Project Name: AT&T (2017-288)

Project Location: 321 SE 2nd Street

Request: Class I Site Plan Modification

Application Type: Class I Site Plan Modification –
AT&T Fence Replacement – 321 SE 2nd St

SHEET TITLE: **SITE PLAN CIVIL**

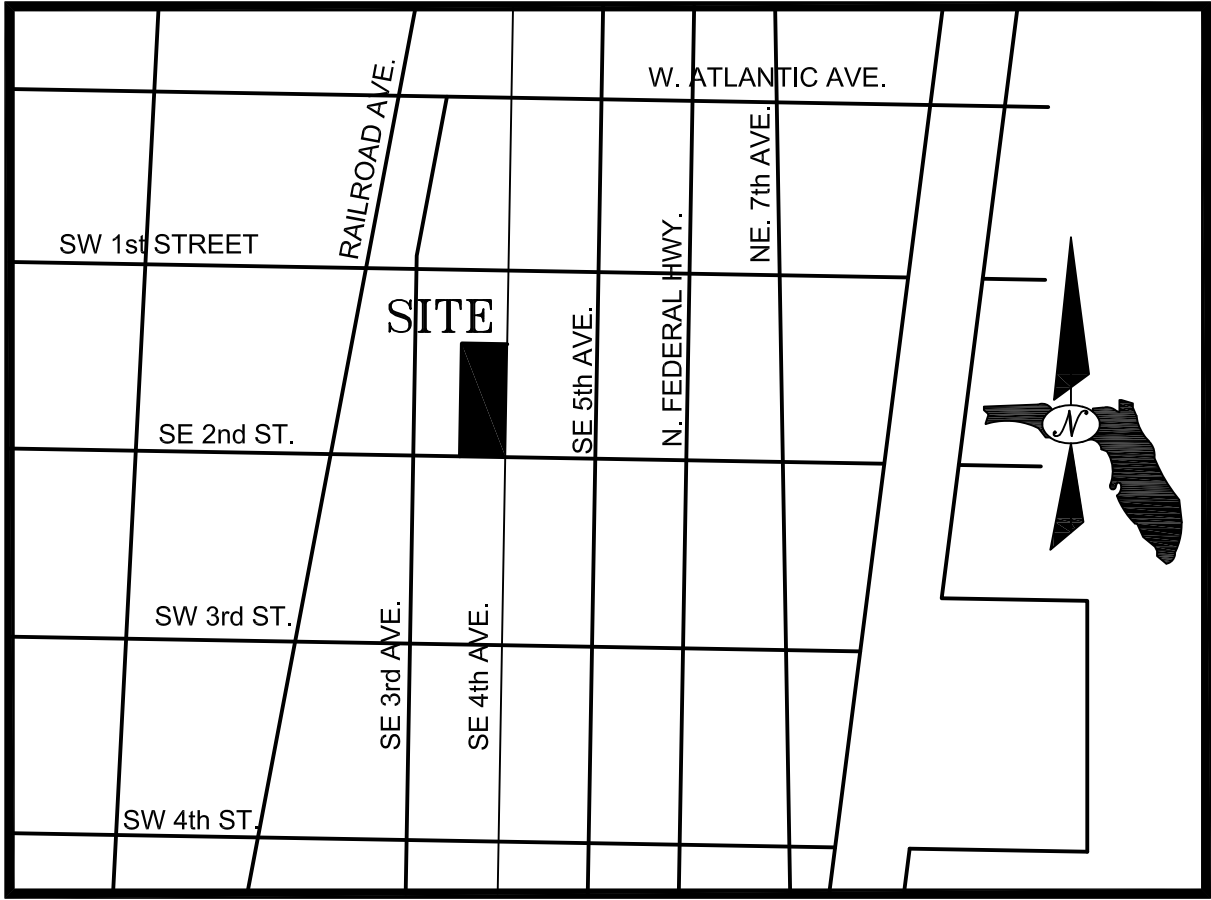
- ✓ Site plans shows that a one-way driveway is proposed. Per LDR Section 4.6.9(D)(3)(b) a minimum width is 12' for a one-way driveway and 24' is provided. Parking space dimensions are correct dimensions thus meeting the code requirement.

- ✓ Site plan shows clearly marked directional arrows thus meeting the code requirement.

- ✓ Site plan shows that each parking space has a precast concrete wheel stop thus meeting the code requirement.

- ✓ The Florida Accessibility Code for Building Construction and Federal ADA requires 1 ADA compliant space for every 25 spaces up to the first 100 spaces. As the project consists of 29 parking spaces, 2 ADA compliant spaces are required. The site plan shows 2 ADA parking spaces, thus meeting the code requirement.

- ✓ The number of parking spaces at this site is 29 parking spaces out of which 5 spaces are designated as compact parking spaces making compact parking spaces 17% of provided parking. Site plan shows that compact parking spaces are marked thus meeting the code requirement.

- ✓ The proposed redesign of the parking lot introduces a one way driveways thus having one ingress entrance separate from one egress exit point. The site plan shows 20 feet of a stacking distance between the right-of-way and the first parking space thus meeting the code requirement.

- ✓ Site plan shows that 10' sight visibility triangles are provided on both side of the exiting driveway, thus meeting the code requirement.
